Document Number
D17/13875

COMMENTS FROM WESTERN NEIGHBOUR

I am writing to comment on the proposed extension at 34A Hawkstone St, Cottesloe.

LOT 2 34/A HAWKSTONE STREET, COTTESLOE - PROPOSED ADDITIONS	
[SCALE (or A3)]	
1:50 [VISUAL REPRESENTATION ONLY]	[DATE]
NORTH ELEVATION	SEPTEMBER 2017
S. DEVINE	[DRAWING]
	A01

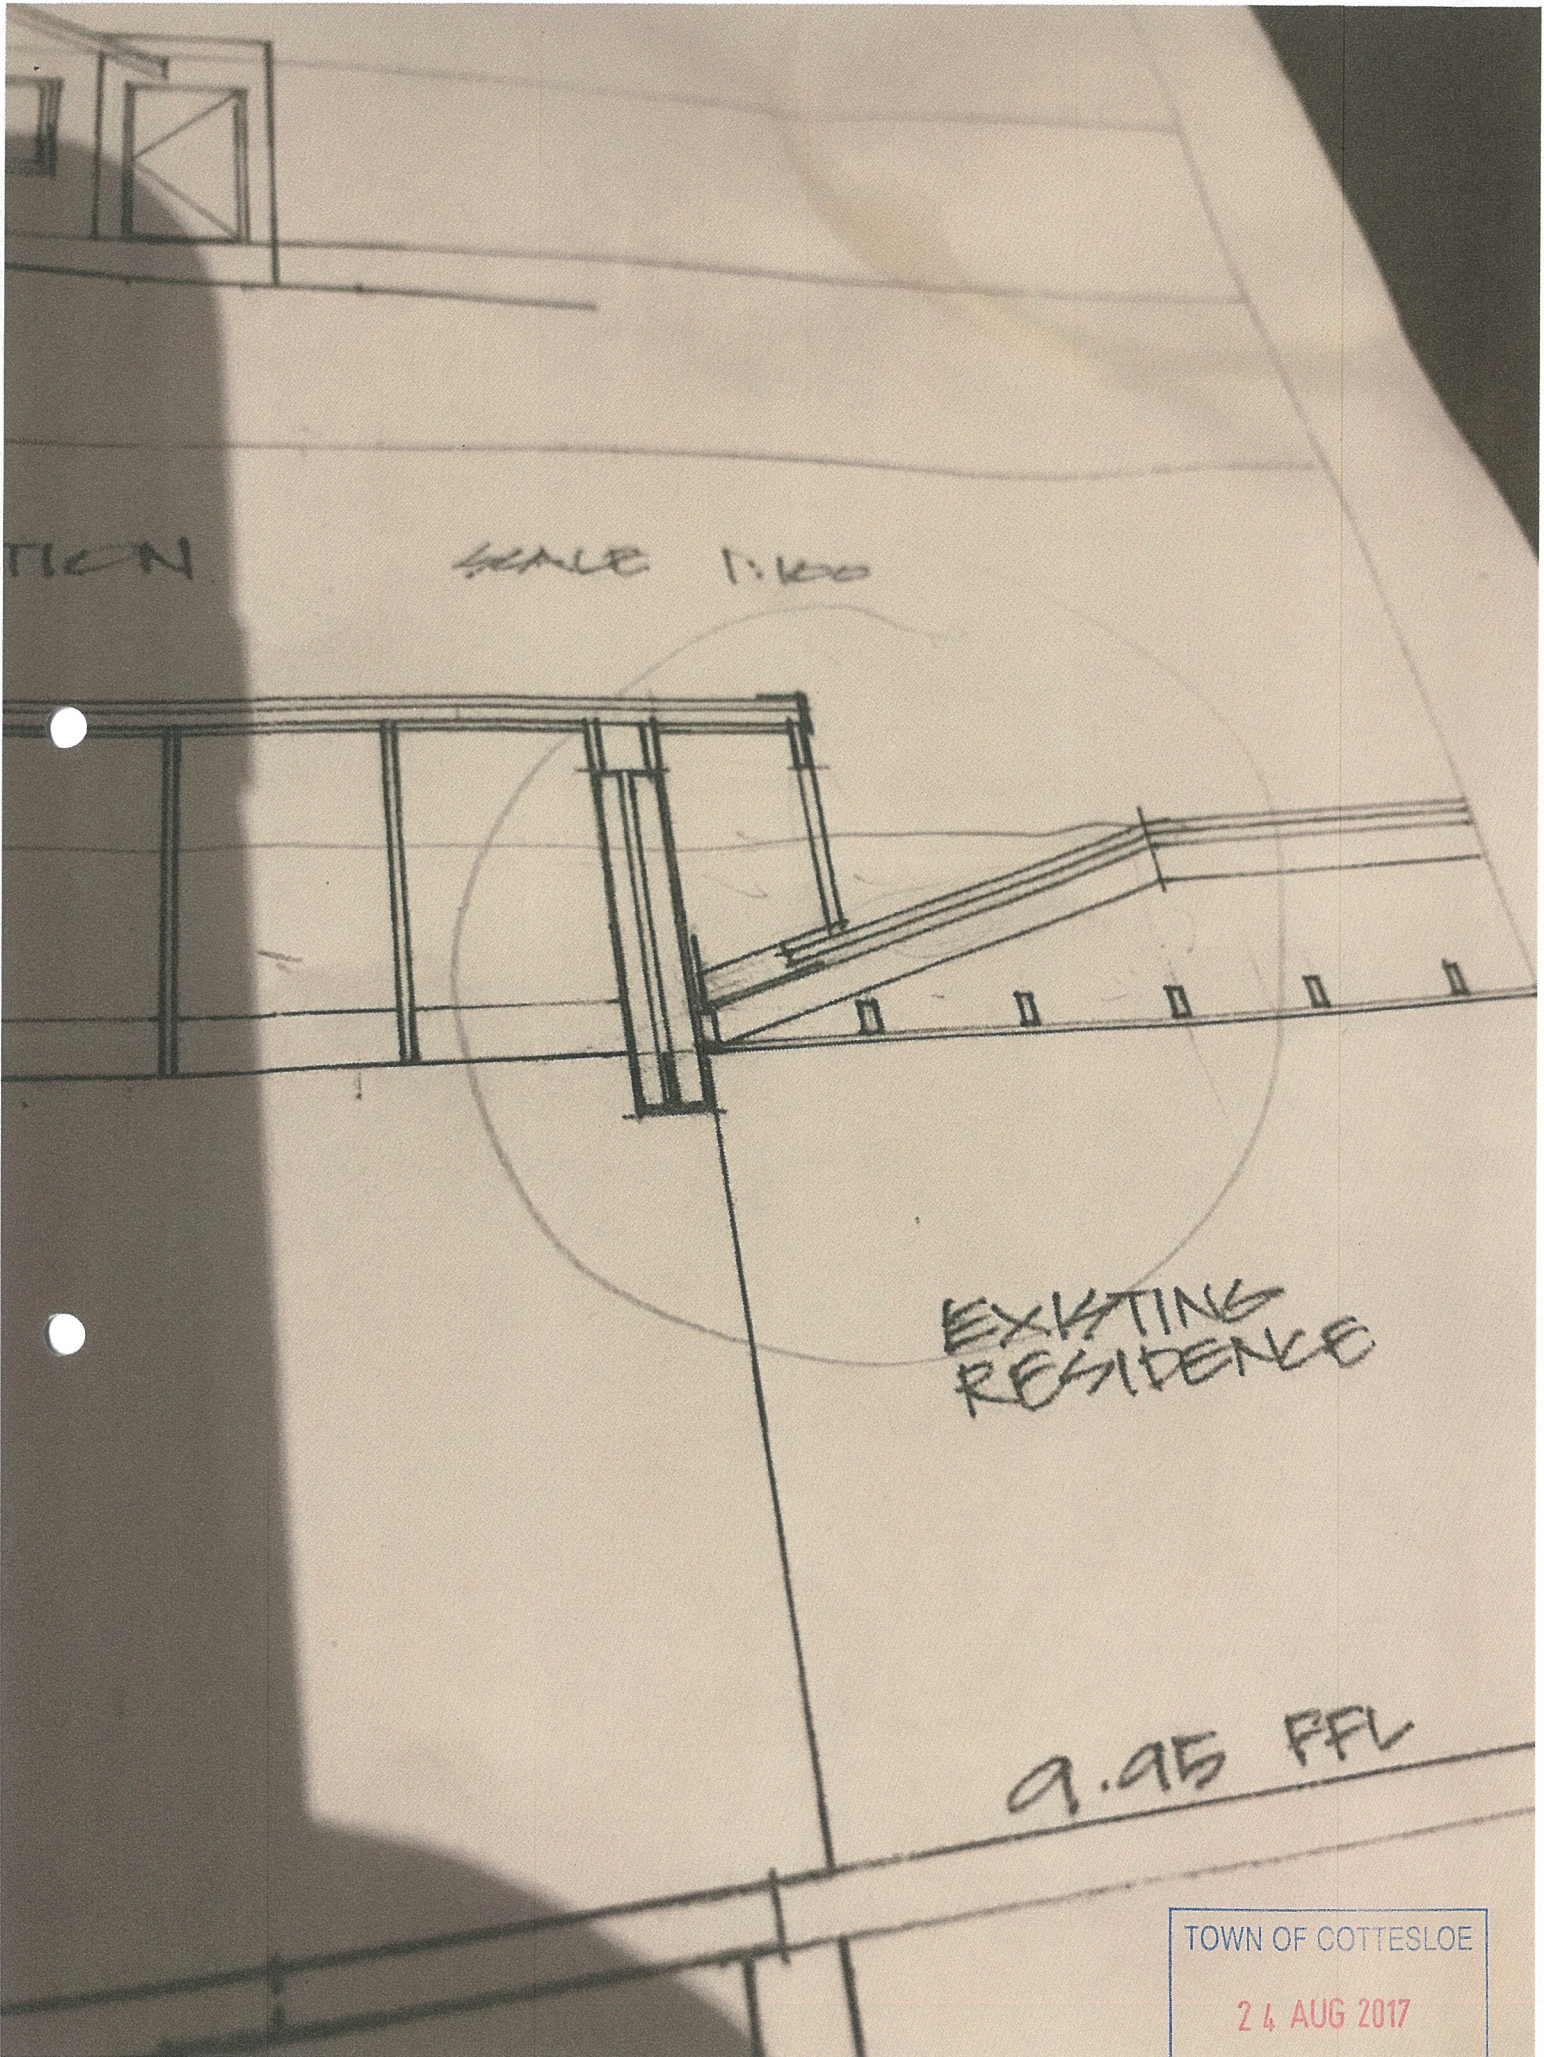
The rooflines on 34 Hawkstone St are not shown clearly on the plans submitted to Council and I have circled this area in the photo.

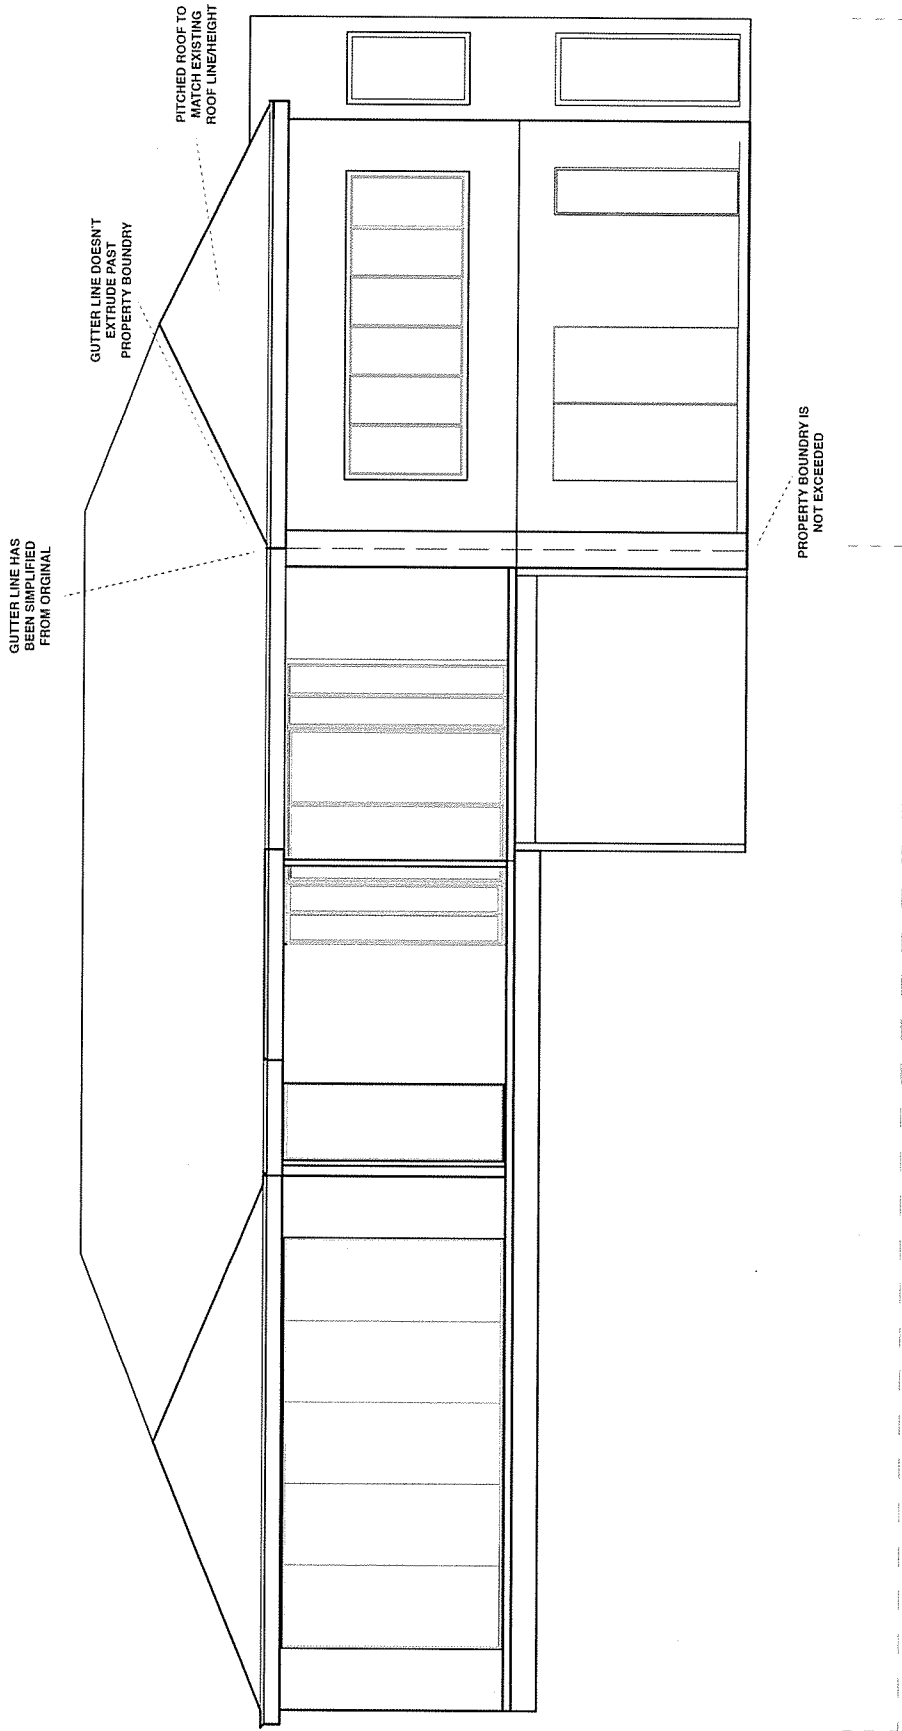
3. The drawing does not appear to show any drainage solution for the water coming down the western eave or where the new building meets the existing building's roofline on the south side (the front) of the existing building. I have serious concerns relating to drainage specifically because there is no mechanism shown on the drawings to deal with the water in either of these areas. The area where the existing roof and the new extension meet does not appear to ??

4. I acknowledge that the additions to the front of the building are shown to have a zincaluminum roof and it would be my preference to see this carried throughout the entire building rather than having the front half of the building zincaluminum and leaving the remainder of the building tiled, creating a sympathetic aspect for both properties. My builder has also raised concerns regarding drainage issues where tile and zincaluminum join.

WEST ELEVATION
 SCALE 1:100

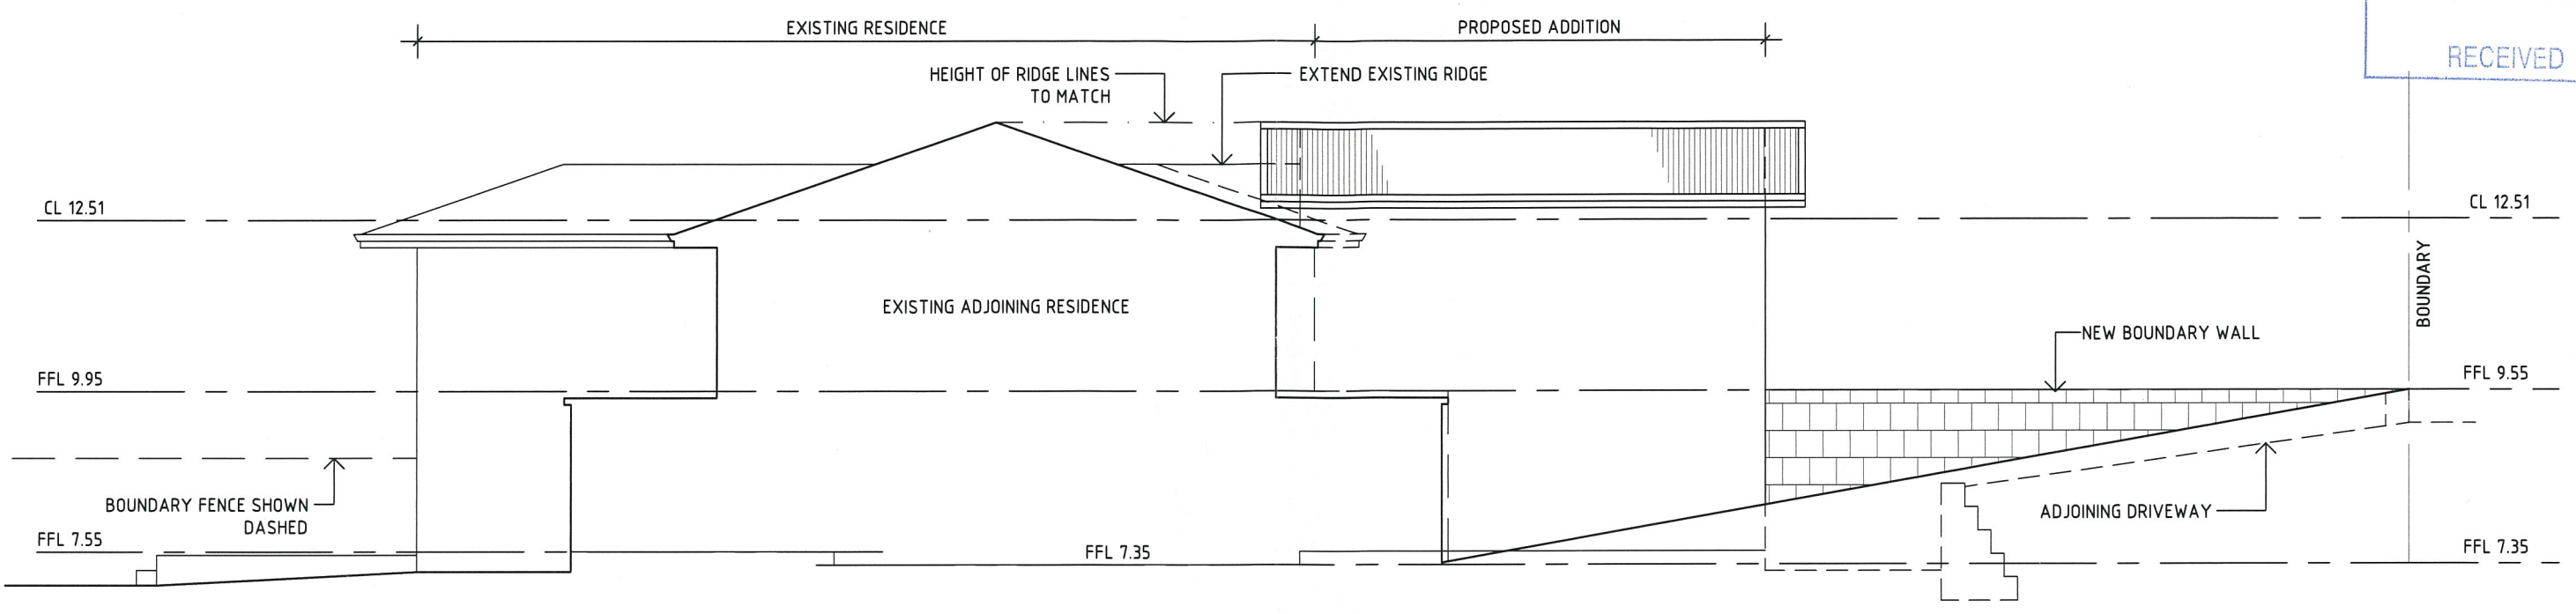
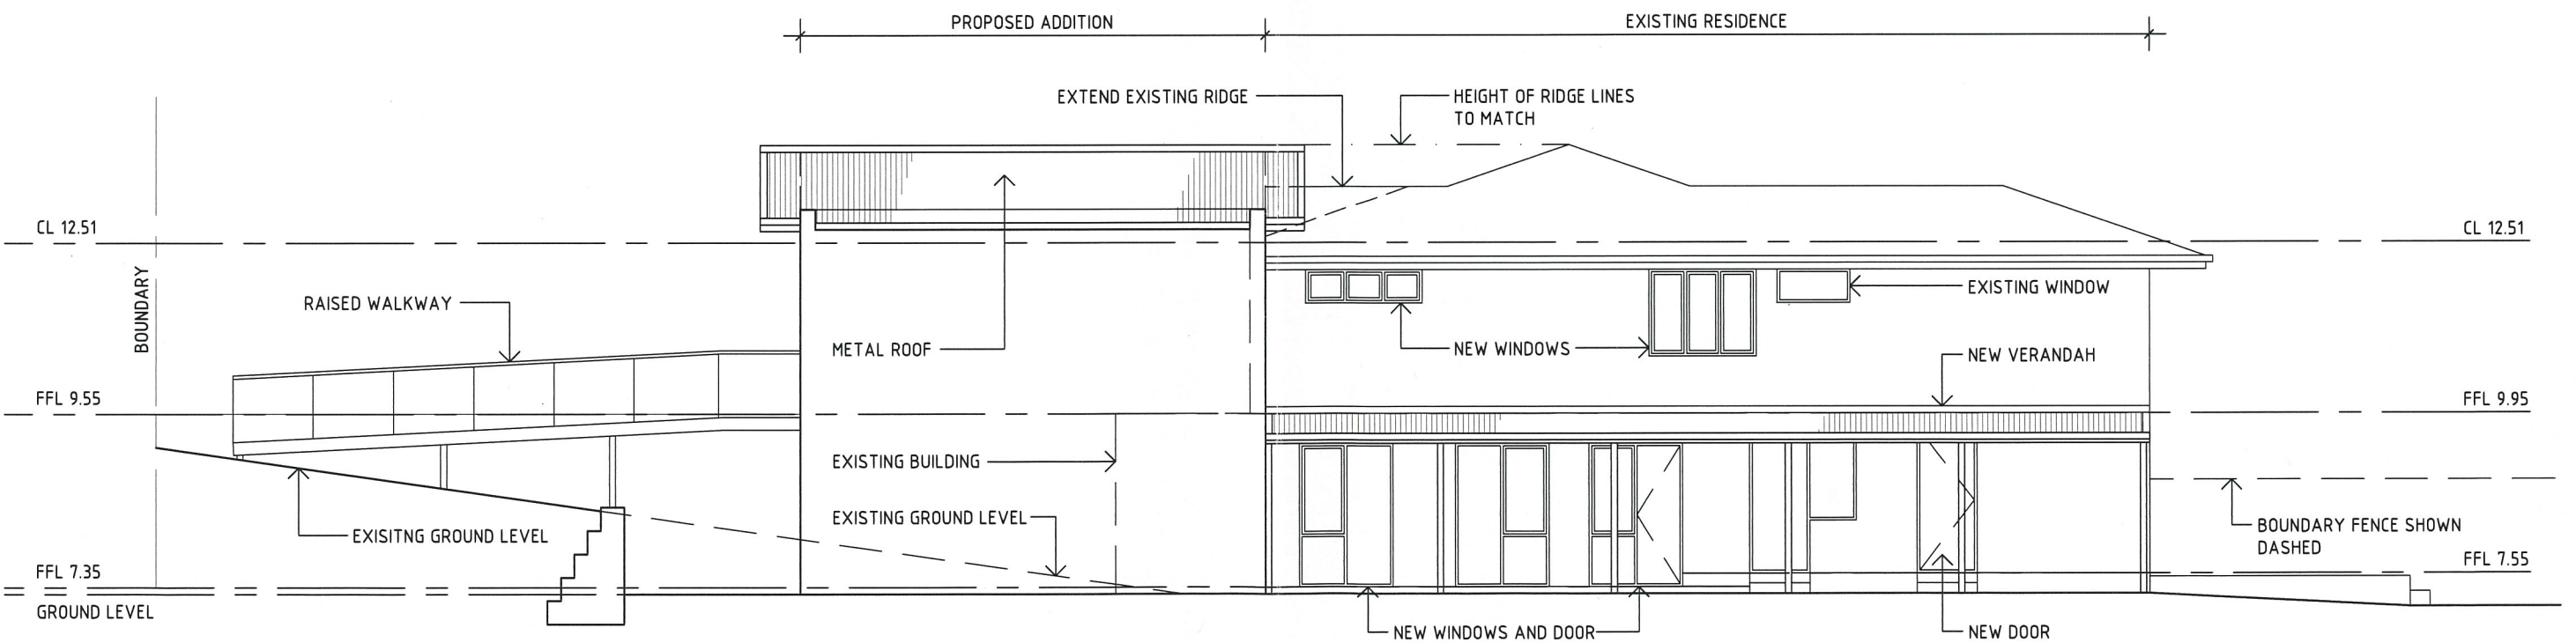
I would be just a little concerned about how close that double story wall would be to our boundary line and how high compared to how it is at the moment.

- How close that double story wall would be to our boundary line and how high compared to how it is at the moment. There are bedroom windows on the western side of the house, so worried about extra noise and less light.
- Possible overlooking from the new kitchen window.

As detailed on the proposed plans the height of the wall in question is approximately 300mm taller than the existing external structure's wall however this is only to a short length of the overall building length and the overall building height is lower than the existing structure's ridge line.

The overall height of the proposed extension is well below the maximum R-code height allowable for this building given the existing ground RLs. This has been done intentionally to minimise the impact of the proposed structure on the streetscape presence (given its projection forward towards the street front boundary). This also minimises any potential overshadowing of the adjacent building. We note that the neighbouring property is on the eastern side of the proposed extension works so this will not substantially reduce any northern light entering into the neighbouring home.

The proposed extension has a stairwell void area between the new lounge/bedroom areas and the neighbouring property and the external wall will be a double brick wall with no openings at all towards the eastern neighbour. The removal of the entrance gate and cessation of the use of the front door at the top of the current external staircase (now the primary access to our house; and adjacent to the downstairs habitable areas of the eastern neighbour) will remove all current noise impact of the gate and/or door opening and closing multiple times a day. The proposed main entrance door faces the street and is set back from the front of the neighbour's house by approximately 2 metres. The proposed plan will have much reduced noise impact on the neighbour's habitable areas. As there are no openings in the proposed eastern external wall, sound transmission will be non-existent.
